Additional documents

Planning Committee

Wednesday 2 November 2022 6pm

PC2211-2 DEFERRED JDAP ITEM- AMHERST STREET, NOS. 34-38 (LOTS 1823, 1209, 1212, AND 1217) AND STACK STREET, NOS. 2-4 (LOTS 1223 AND 1222), FREMANTLE – 56 GROUPED DWELLINGS) (JCL DAP001/22)

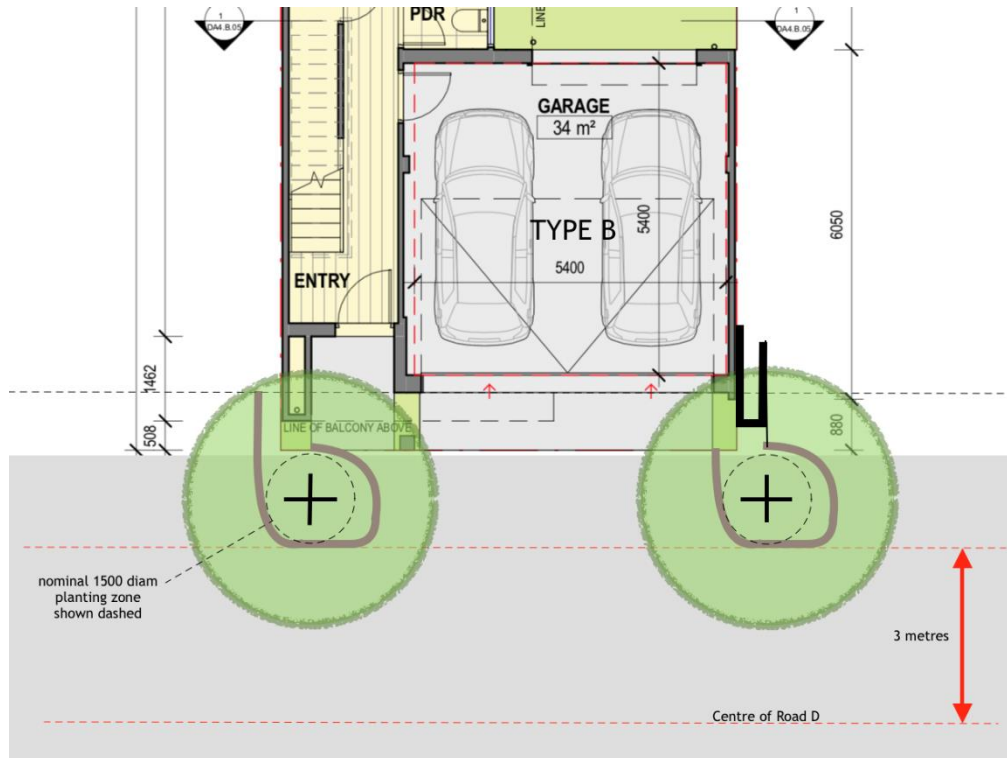
In relation to the onsite landscaping, the City anticipates a satisfactory landscape plan would include the provision of at least 21 trees in 'Road A', 6 trees in 'Road B', 2 trees in 'Road C', 8 trees in 'Road D', and 5 trees in the Laneways. The City also anticipates that the Condition 9 requirement for alternative methods generating canopy cover would be satisfied where vertical vegetation and/or vegetated trellising is provided in the Laneways and Road C.

The development includes very small courtyards that typically have two storey walls all around. It is unlikely that a satisfactory level of canopy cover will be achieved or maintained in the private courtyards alone. The private roads include large areas of paving but are of sufficient width to incorporate a tree in front of most dwellings without compromising vehicle movements, as demonstrated in the sketch below.

As such, the available space in the private roads is more likely to generate adequate canopy cover and greater certainty that the trees will be maintained for the life of the development by way of a condition of approval. It is acknowledged that in some areas it will not be possible to generate sufficient space for a tree in front of each dwelling and where this is not practical due to the narrow width of the laneways, alternative methods of establishing vegetated canopy cover over paved private roads needs to be included in the landscape plan. The amendment is based on the indicative distribution of plantings shown in the sketch below.

- 9. Prior to the issue of a building permit, a detailed landscaping plan that addresses onsite landscaping in common property, including information relating to species selection, reticulation, details of existing vegetation to be retained, and treatment of landscaped surfaces (i.e. mulch, lawn, **synthetic-grass** etc), shall be submitted to and approved by the City of Fremantle, *and shall include deep root planting areas for a minimum of 42 medium sized trees located within the private roads, and where trees are not possible in due to confined space, alternative methods of providing adequate canopy cover, including vegetated trellises shall be provided. The landscaping shall be implemented prior to the occupation of the development and be maintained for the life of the development to the satisfaction of the City of Fremantle.***
